# Access Compliance Report

## Public Rights-of-Way

Intersection ID: 19457	Main Street: S_TRYON_ST	Cross Street: YORKDALE_DR	Location: SW
ADA ID: 1FEF6C150F9B	Ramp Type: PerpDiag	Initial Pass/Fail: Fail	Overall Compliance: No
		Severity Score: 10

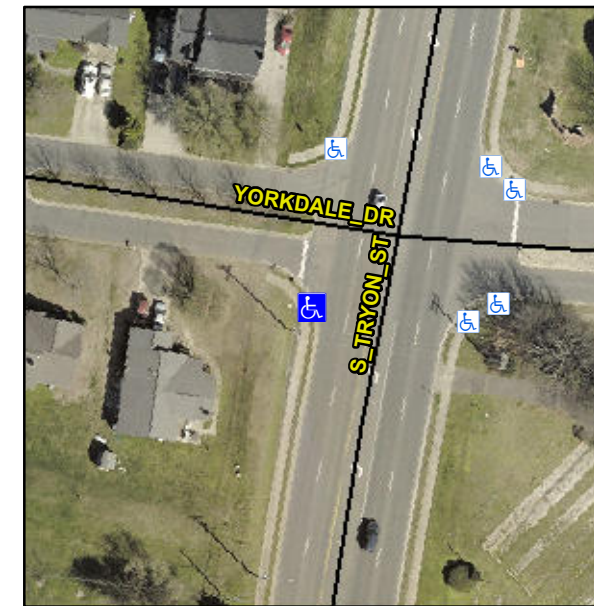
**Not Found, R304.5.1, R304.5.3**

Compliance	Description	Data	Compliance	Description	Data
N/A	Ramp Length (in)	88.0	Yes	Ramp Slope (%)	7.8
No	Ramp Width (in)	43.0	No	Ramp XSlope (%)	3.7
N/A	Flare Type LT	N/A	N/A	Flare Type RT	N/A
N/A	Flare Slope LT (%)	N/A	N/A	Flare Slope RT (%)	N/A
N/A	Flare Traversable LT?	N/A	N/A	Flare Traversable RT?	N/A
N/A	Landing Length (in)	N/A	N/A	DWS Provided?	N/A
N/A	Landing Width (in)	N/A	N/A	DWS Contrast?	N/A
N/A	Landing Slope (%)	N/A	N/A	DWS Length (in)	N/A
N/A	Landing X Slope (%)	N/A	N/A	DWS Full Width?	N/A
N/A	Landing Curb? (Y/N)	N/A	N/A	DWS Offset (in)	N/A
N/A	Shared Landing?	N/A			
N/A	Gutter Ponding?	N/A	N/A	Gutter Slope (%)	N/A
N/A	Gutter Lip Ht (in)	N/A	N/A	Gutter X Slope (%)	N/A
N/A	Painted X Walk1?	No	N/A	Painted X Walk2?	No
	X Walk 1 Direction	To E		X Walk 2 Direction	To N
N/A	X Walk 1 Width (in)	N/A	N/A	X Walk 2 Width (in)	N/A
	X Walk 1 Slope (%)	2.7		X Walk 2 Slope (%)	4.4
	X Walk 1 X Slope (%)	2.6		X Walk 2 X Slope (%)	1.9

**Remove & Replace Curb Ramp With Two New Directional Ramps or Equivalent.**
